PLANNING DEPARTMENT – Development Review Services

November 10, 2016

**RE: DAVITA Albuquerque
Grading and Drainage Plan
Engineer's Stamp Date 10-10-2016 (File: K21D009H1)**

Based upon the information provided in your submittal received 10-12-2016, the above referenced plan is approved for Building Permit and for SO-19 Permit with the following conditions:

SIDEWALK CULVERT DETAIL

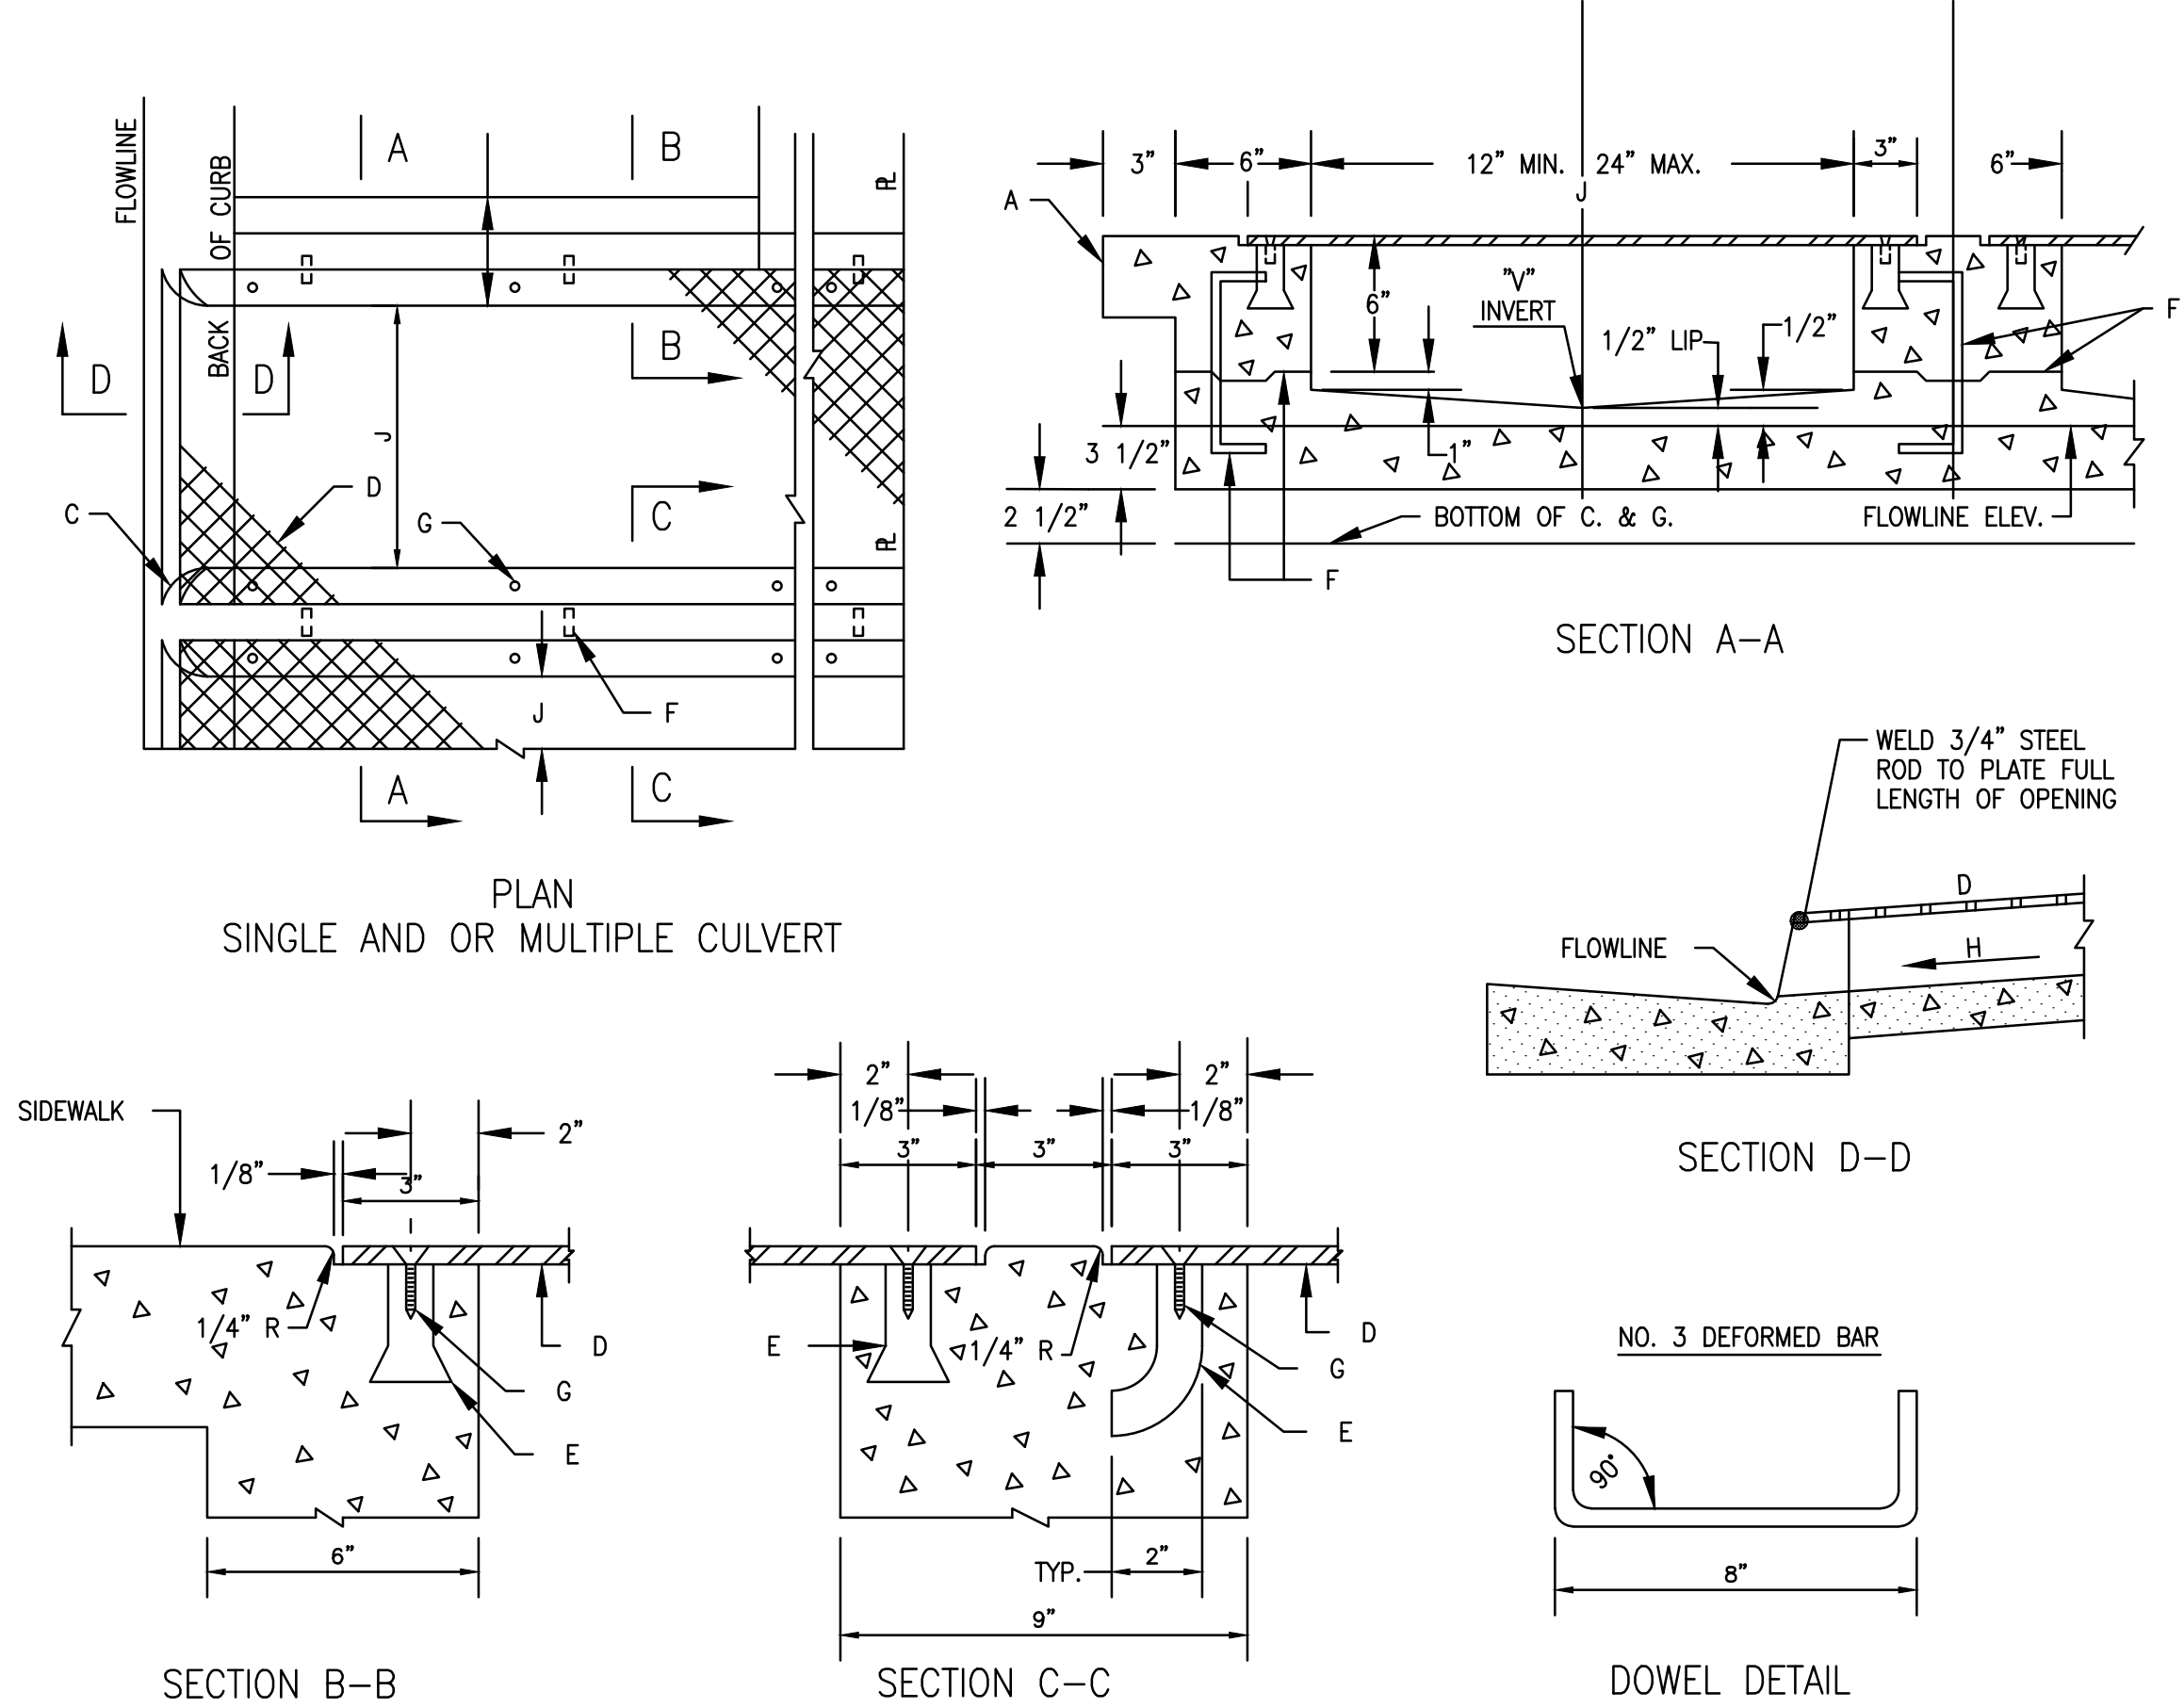
1. Extend the sidewalk culverts 1-foot behind the sidewalk.
2. Specify to the Contractor the intended size of the culverts. The standard detail only shows the acceptable opening widths. Note that the minimum width of the culvert is based on the opening of the channel.
3. References to the Drainage Master Plan for the Copper Pointe Development should have been included in the Plan. However, this project does appear to total a smaller impervious footprint than the development anticipated by the master plan for Copper Pointe (a parking lot extension and building with minimal landscaped islands).
4. An approved ESC Plan is secured through the Stormwater Quality Engineer.
